APPLICATION

SEWAGE DISPOSAL TESTING

MARYLAND STATE DEPARTMENT OF HEALTH

ROAD AND DESCRIPTION *Daniels Rd., Ellicott City, Md.*

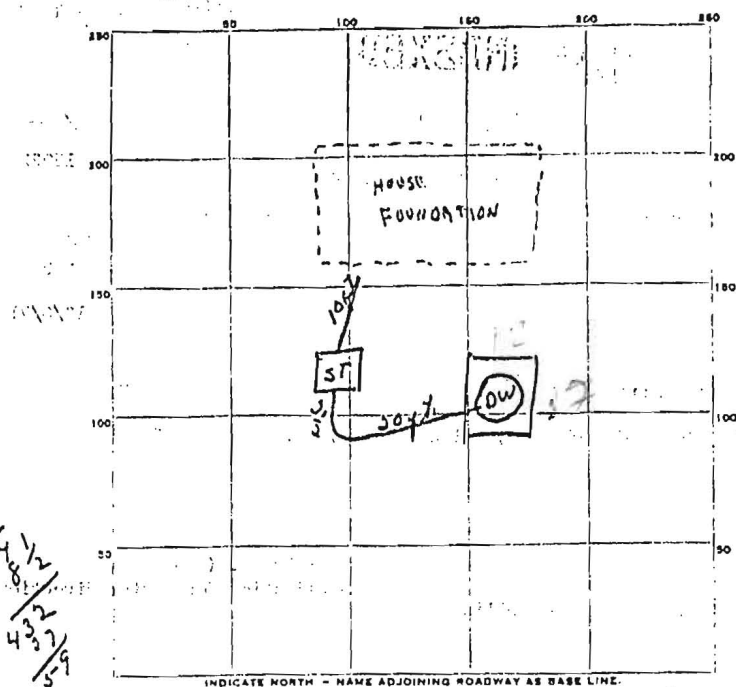
Dry Well - 300 sq. ft. abundant, sidewalk area

To begin below the outlet. Maximum depth permitted for dry well is 9 1/2 ft. below original grade. Locate dry well 60 ft. from depth water line and 60 ft. from rear property line as shown. Daniels Rd. Well has to be at least 75 ft. and upgrade

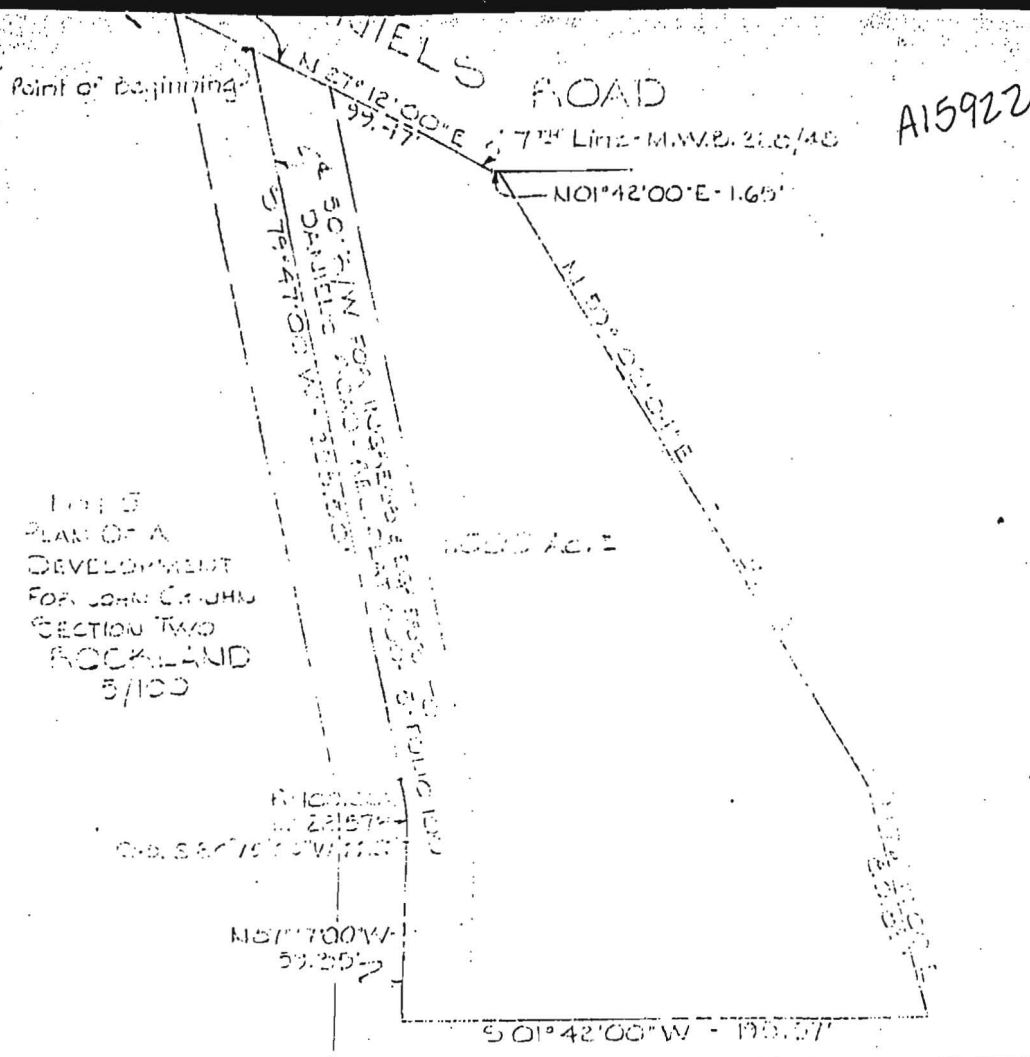
REMARKS 12/14/71 - Checked location and depth (10ft). Same approved to
continue
R.T.F.F.

12/20/71 ALL PIPE IS CAST IRON.

SEWER LINE NOT CONNECTED TO HOUSE.

5ft to house will be installed by plumber.
